TDL #275 and #276 D2.1

Addressing comments: #108, #420, #421, #281

PSE-PD stability

33A.1 Recommended PSE design guidelines and test setup

Figure 33A–1—PSE-PD system impedance allocation

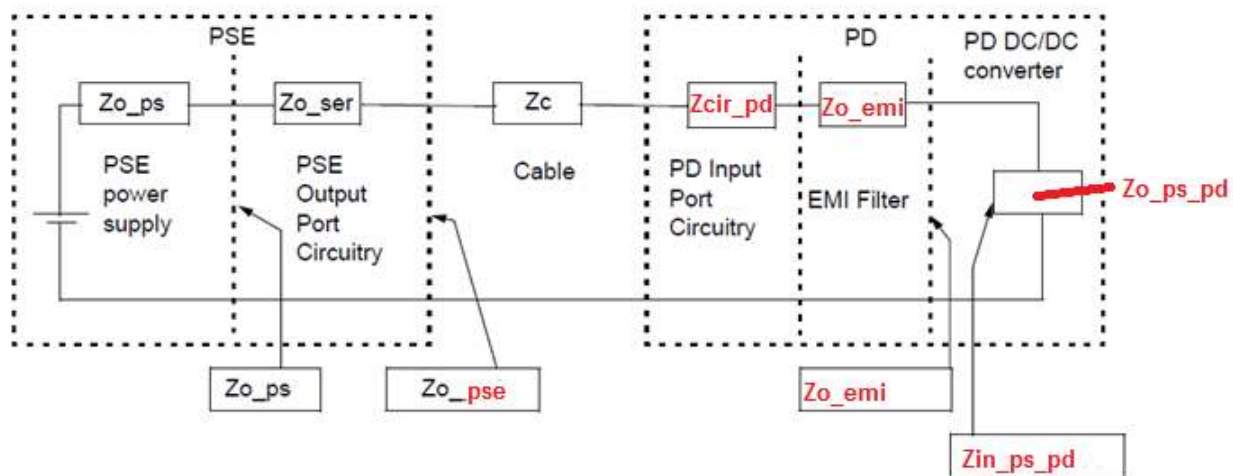
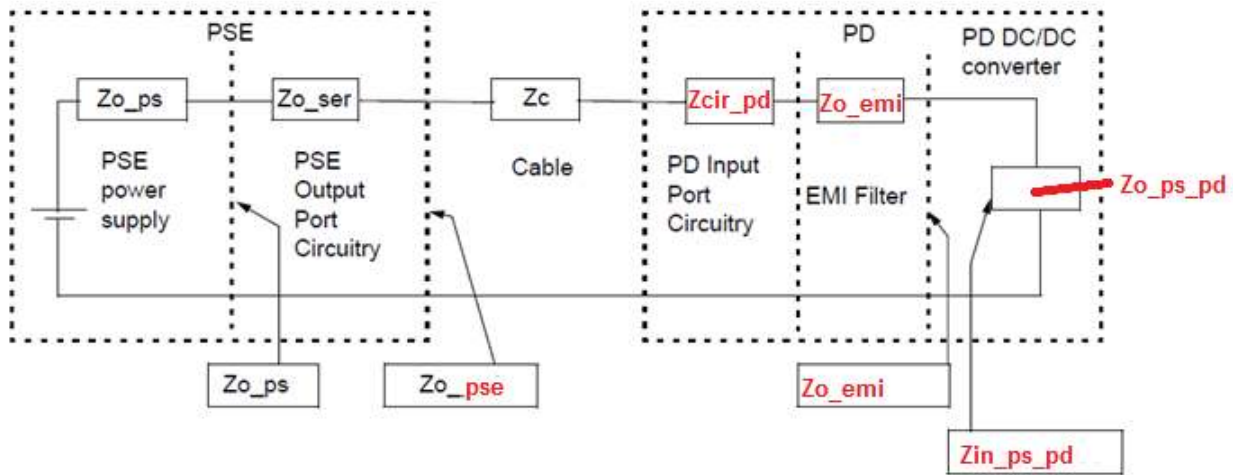
In order to prevent potential oscillations between the PSE and PD, the sum of the PSE port output impedance (~~Zo_port~~Zo_pse), the cable impedance (Zc), the PD input port circuitry impedance (~~Zpd_cir~~Zcir_pd) and the PD EMI output filter impedance (Z_emi) should be lower than the PD power supply input impedance (Zin_ps_pd). All the above impedances are converted to the equivalent series impedance form as described by Figure 33A-1. ~~This sub-clause focuses on the PSE part.~~ [Redundant: It is in the title]

2. Update Figure 33A-1 as follows:

In order to prevent potential oscillations between the PSE and PD, the sum of the PSE port output impedance (Z_{o_pse}), the cable impedance (Z_c), the PD input port circuitry impedance (Z_{cir_pd}) and the PD EMI output filter impedance (Z_{emi}) should be lower than the PD power supply input impedance ($Z_{in_ps_pd}$). All the above impedances are converted to the equivalent series impedance form as described by Figure 33A-1. [Redundant: It is in the title]
